UNITED STATES PATENT AND TRADEMARK OFFICE

APPLICATION NO.	FILING DATE	FIRST NAMED INVENTOR	ATTORNEY DOCKET NO.	CONFIRMATION NO.
10/718,561	11/24/2003	Myoung-Kee Baek	42165-0009	1881
30827	7590	02/08/2006		
MCKENNA LONG & ALDRIDGE LLP 1900 K STREET, NW WASHINGTON, DC 20006			EXAMINER EVANISKO, LESLIE J	
			ART UNIT 2854	PAPER NUMBER

Office Action Summary	Application No. 10/718,561	Applicant(s) BAEK ET AL.	
	Examiner Leslie J. Evanisko	Art Unit 2854

DETAILED ACTION

FIG. 8A

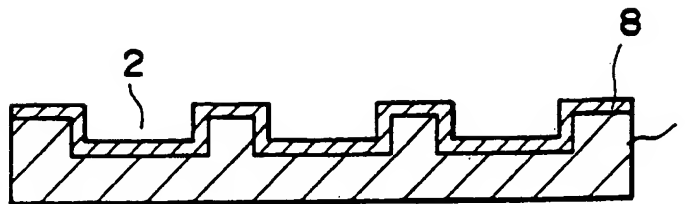
appears that the cliché shown in Figures 6A-6D, 7A-7E, and 8A-8C of Okazaki et al. meet that relationship--as pointed out by the Examiner in the marked-up copy of Figures 6B, 7C, and 8B attached to this Office Action, which illustrates what structure the Examiner is considering to be the first and second groove structures and interval as recited. Regardless, it would have been obvious to one of ordinary skill in the art to provide a cliché having first and second groove structures with the size relationship as recited, as the particular sizes and arrangements of the groove structures of the cliché are dependent upon such factors as the particular configuration of the pattern desired to be printed, the desired thickness of pattern to be printed, the viscosity of the material being printed on the substrate, etc.

FIG. 8B

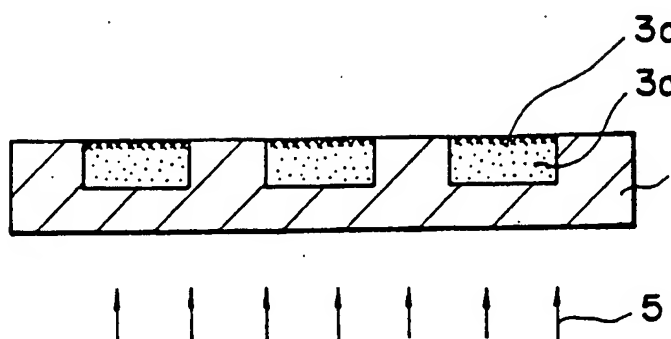
With respect to claim 5, note Okazaki et al. teach applying the resist material 3 onto an etching object layer comprises contacting and rotating a printing roll 9 onto the cliché 1 to transfer the resist material to a surface of the printing roll and contacting the resist material formed on the surface of the printing roll to transfer the material to an etching object layer of the substrate 6, as shown in Figures 7D-7E and 8B-8C in particular.

FIG. 5

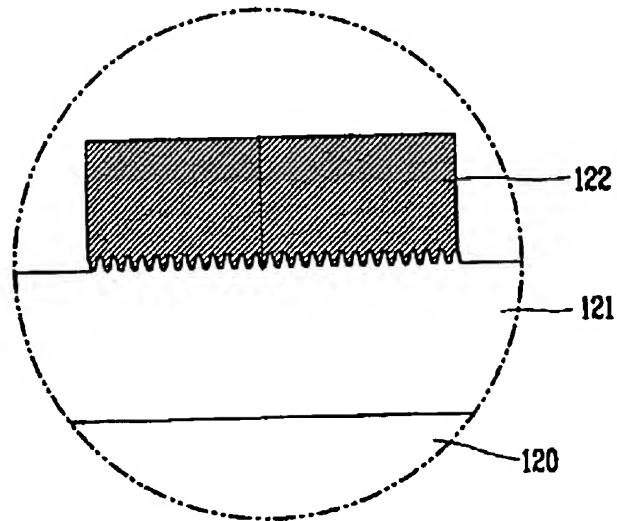
With respect to claim 6, note Kwon et al. teach applying the resist material onto the etching object layer can also be accomplished by a direct contact printing step as shown in Figure 5 and described in paragraph [0047]. In particular, the applying step shown in Figure 5 includes contacting the etching object layer with the cliché and detaching the substrate from the cliché to transfer the resist material from the grooves to the etching object layer. Note that the direct contact of the cliché and substrate would inherently include application of pressure to the substrate to some extent.
